SAVANNA AT CASTLE ROCK RANCH 9TH ADDITION TO SEDGWICK COUNTY, KANSAS

Re: S/D 97-31 - Final Plat of SAVANNA AT CASTLE ROCK RANCH 9TH ADDITION

STAFF REPORT

CASE NUMBER: S/D 97-31 -- SAVANNA AT CASTLE ROCK RANCH 9TH ADDITION

SAVANNA AT CASTLE ROCK RANCH 9TH ADDITION
TO SEDGWICK COUNTY, KANSAS

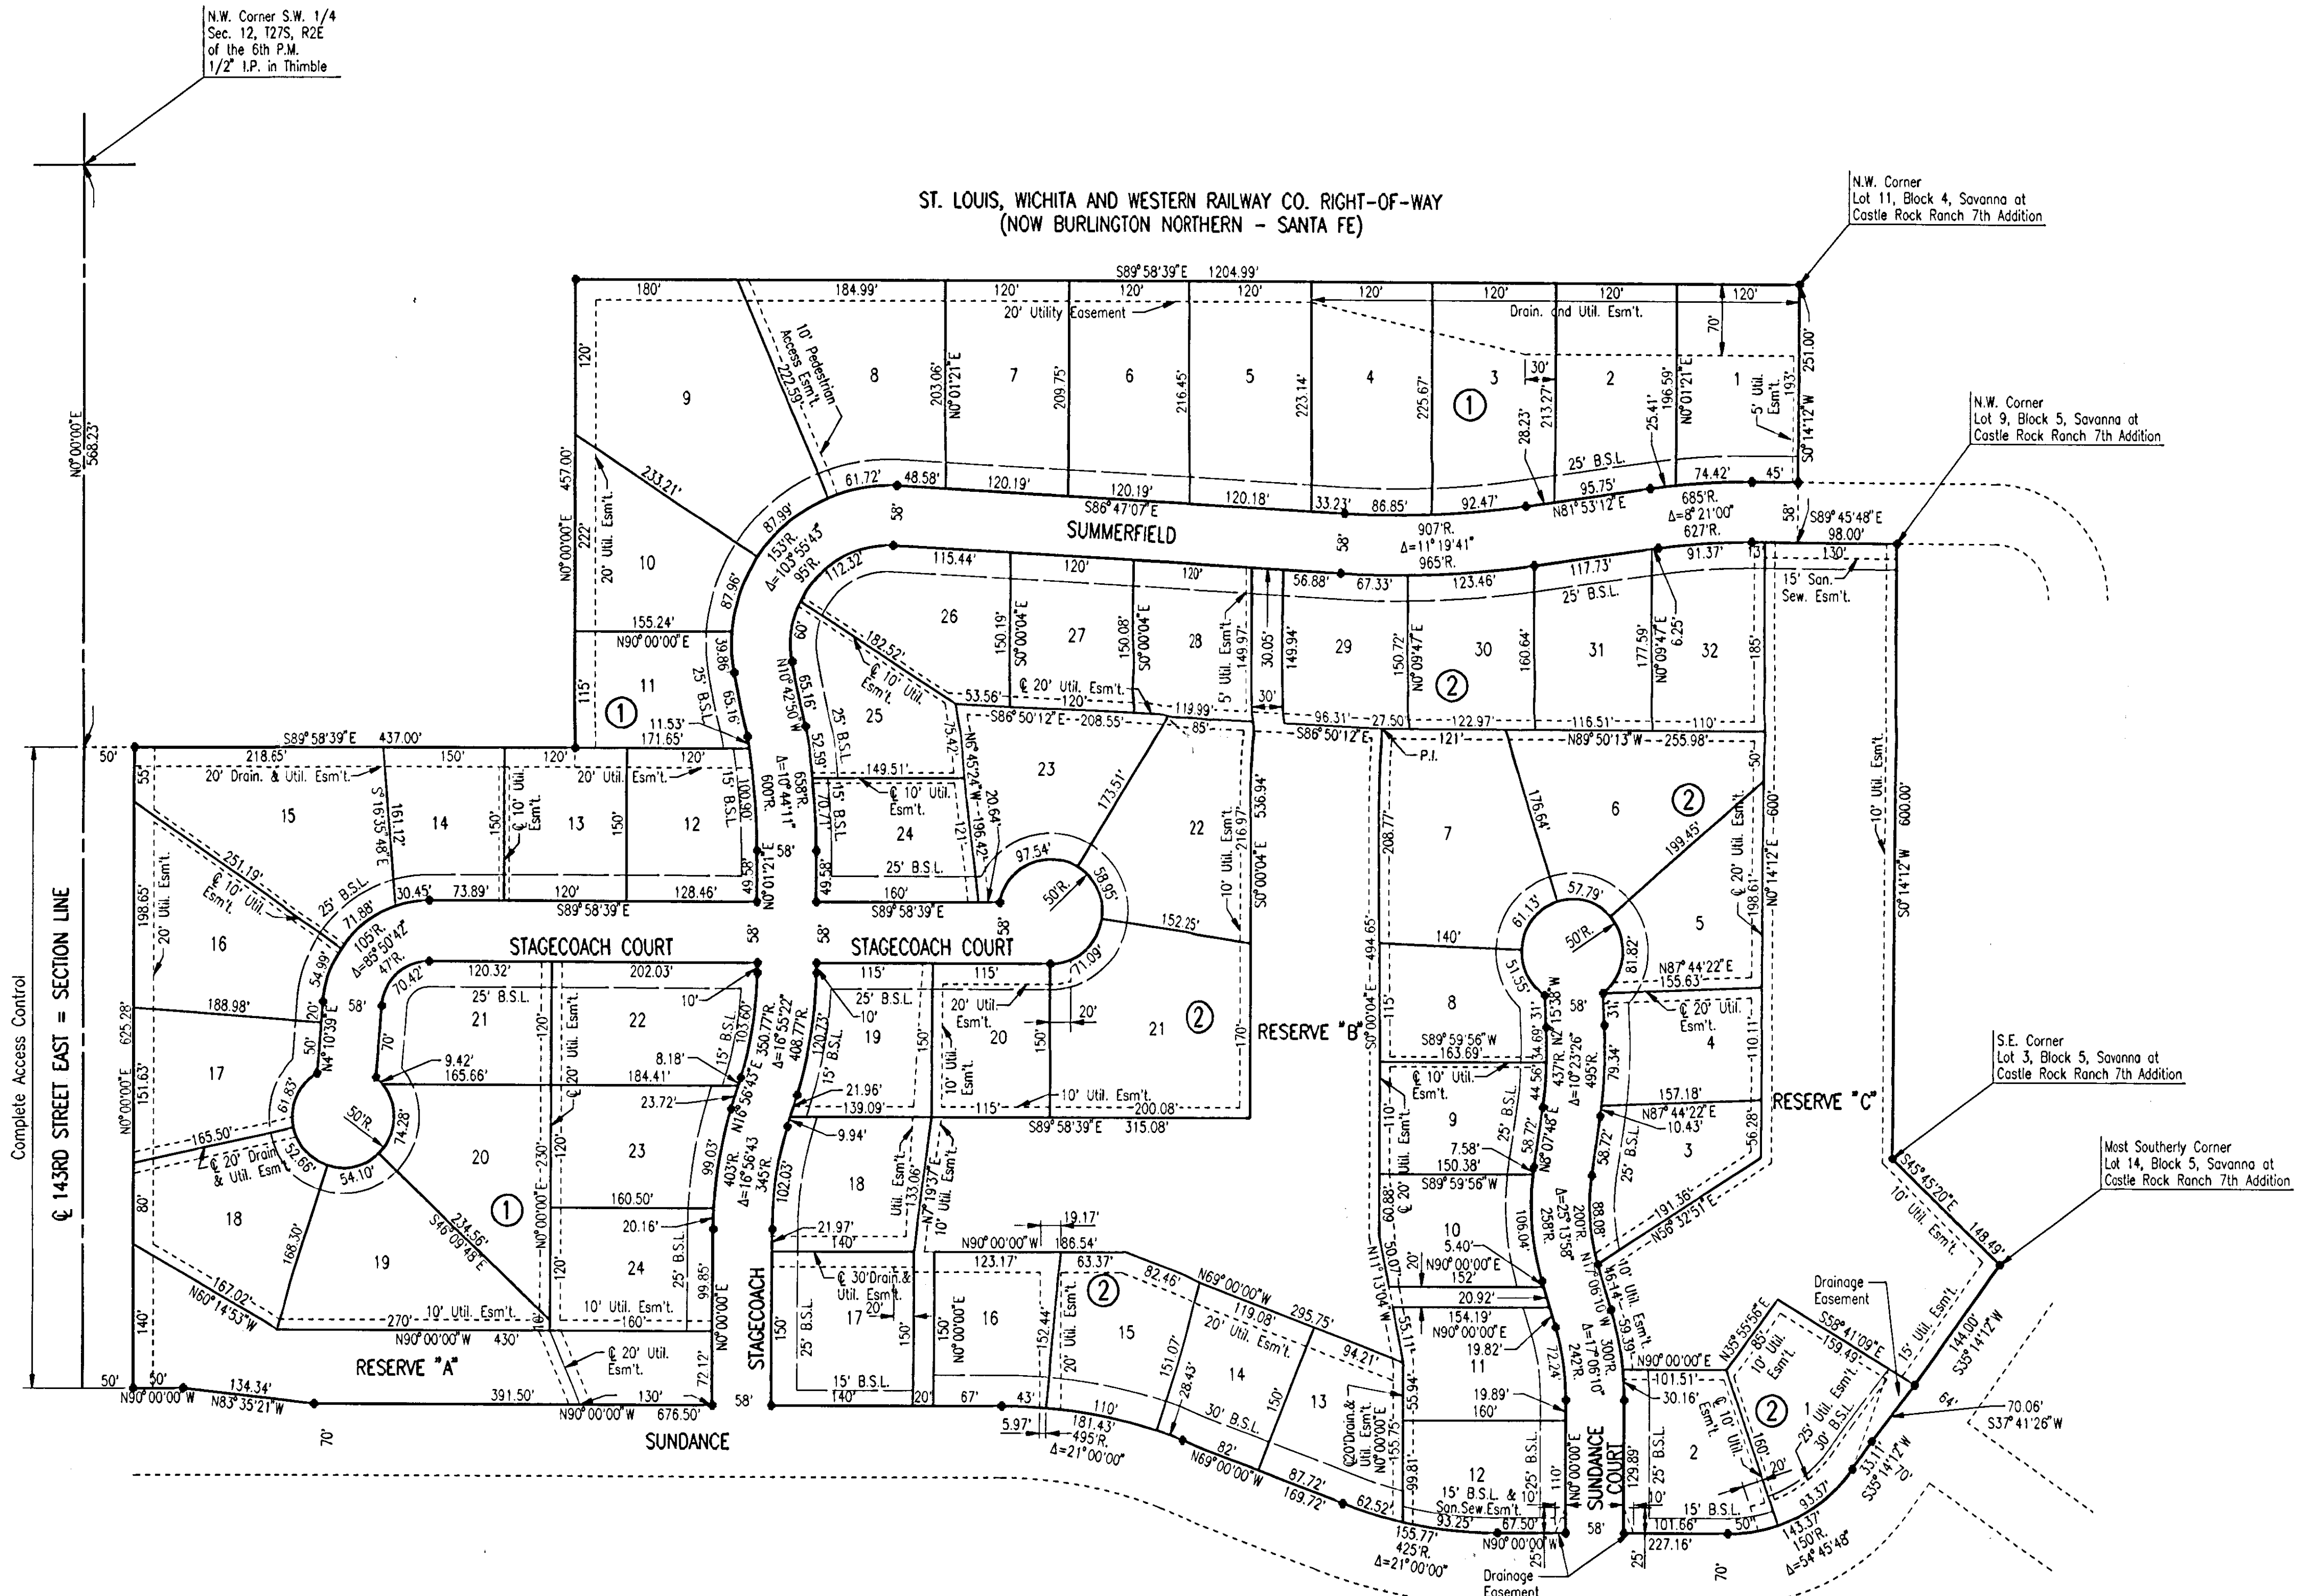
- A. The applicant shall resubmit any City petitions previously involved with the platting of this site. In regard to County guarantees, as requested by the County Engineer, the applicant shall pay off specials for areas designated as reserves or any abandoned facilities, and provide appropriate guarantees for sewer, and paving as required by the County Engineer.

- B. A new outside-the-city water agreement shall be provided for this replat.
- C. If improvements are guaranteed by petition, a notarized certificate listing the petitions shall be submitted to the Planning Department for recording. As appropriate, both City and County Certificates of Petitions shall be provided.

- D. This plat will be subject to approval of the associated zone change (SCZ-0739) and any related conditions of such a zone change. The final plat will not be scheduled for Subdivision Committee review until the zone change has been approved by the County. SCZ-0739 was approved on 5/07/97 (SF-20 to SF-6).

- E. The final plat shall state in the platter's text the purposes of the proposed reserves as well as who is to own and maintain the reserves.
- F. Provisions shall be made for ownership and maintenance of the proposed reserves. The applicant shall either form a lot owners' association prior to recording the plat or shall submit a covenant stating when the association will be formed, when the reserves will be deeded to the association and who is to own and maintain the reserves prior to the

- G. For those reserves being platted for drainage purposes, the required covenant which provides for ownership and maintenance of the reserves shall grant, to the appropriate governing body, the authority to maintain the drainage reserves in the event the owner(s) fail to do so. The covenant shall provide for the cost of such maintenance to be charged back to the owner(s) by a method similar to special assessments.

- H. Since this is a replat of previous Additions involved with the ownership and maintenance of Reserves for these Additions, but not being replatted by this Addition, the above covenants and/or other legal documents shall be provided which provides for this Addition to continue to share in the ownership and maintenance responsibilities of any such previously platted Reserves.

- I. The applicant shall submit a covenant which provides for four (4) off-street parking spaces per dwelling unit on each lot which abuts a 58-foot street. The covenant shall inventory the affected lots by lot and block number and shall state that the covenant runs with the land and is binding on future owners and assigns.

- O. The representatives from County Engineering should be prepared to comment on the status of the applicant's drainage plan. Engineering indicates minimum building pad elevations are required.

- P. The final plat shall indicate the utility easements requested by K.G.& E., which are indicated on the enclosed "marked" copy of the plat.
- Q. As requested by the Planning Department, a means of access (easement, extension of a Reserve area, etc.) needs to be provided from this Addition into the area of Railroad right-of-way along the plat's north line. It is anticipated that this right-of-way will be converted to a recreational corridor, and such access would be to the benefit of the residents in the Savanna Additions. Access has been provided by an easement along Lot 8, Block 1.
- R. Applicant has approval to reduce building setback distance for the 30 feet originally proposed, to the 25 feet permit by SF-6 zoning.

- A. The applicant shall resubmit any City petitions previously involved with the platting of this site. In regard to County guarantees, as requested by the County Engineer, the applicant shall pay off specials for areas designated as reserves or any abandoned facilities, and provide appropriate guarantees for sewer, and paving as required by the County Engineer.

- O. The representatives from County Engineering should be prepared to comment on the status of the applicant's drainage plan. Engineering indicates minimum building pad elevations are required.

- P. The final plat shall indicate the utility easements requested by K.G. & E., which are indicated on the enclosed "marked" copy of the plat.
- Q. As requested by the Planning Department, a means of access (easement, extension of a Reserve area, etc.) needs to be provided from this Addition into the area of Railroad right-of-way along the plat's north line. It is anticipated that this right-of-way will be converted to a recreational corridor, and such access would be to the benefit of the residents in the Savanna Additions. Access has been provided by an easement along Lot 8, Block 1.

- R. Applicant has approval to reduce building setback distance for the 30 feet originally proposed, to the 25 feet permit by SF-6 zoning.

THE 10 FOOT PEDESTRIAN ACCESS EASEMENT SHOWN IN LOT 8, BLOCK 1, IS TO PROVIDE PEDESTRIAN ACCESS TO THE RAILROAD RIGHT-OF-WAY AT SUCH TIME AS SAID RIGHT-OF-WAY IS CONVERTED TO A RECREATIONAL CORRIDOR.

RESERVE "A", "B", AND "C" ARE HEREBY PLATTED FOR DRAINAGE, LAKES, ENTRY MONUMENTS, PARKS, WALKWAYS, RECREATIONAL FACILITIES LANDSCAPING AND UTILITIES CONFINED TO EASEMENTS. RESERVES "A", "B", AND "C" SHALL BE THE SUBJECT OF THE RESTRICTIVE COVENANTS ESTABLISHED BY THE DECLARATION OF OWNER'S ASSOCIATION AGREEMENTS AND SHALL BE OWNED AND MAINTAINED BY ONE OR MORE ASSOCIATIONS TO BE FORMED WITHIN SAVANNA AT CASTLE ROCK RANCH 9TH ADDITION TO SEDGWICK COUNTY, KANSAS.

ALL ABUTTERS' RIGHT OF ACCESS TO AND FROM 143RD STREET EAST OVER AND ACROSS THE WEST LINE OF LOTS 15 THROUGH 18 IN BLOCK 1 AND WEST LINE OF RESERVE "A" ARE HEREBY GRANTED TO THE APPROPRIATE GOVERNING BODY.

MINIMUM PAD ELEVATIONS (LOWEST OPENING) AS FOLLOWS:

BLOCK 2 LOTS	ELEVATION
1 THROUGH 6 AND 32	1350.2 M.S.L.
7 THROUGH 11, 13 THROUGH 22 AND LOTS 28 AND 29	1357.7 M.S.L.
LOT 12	1356.5 M.S.L.
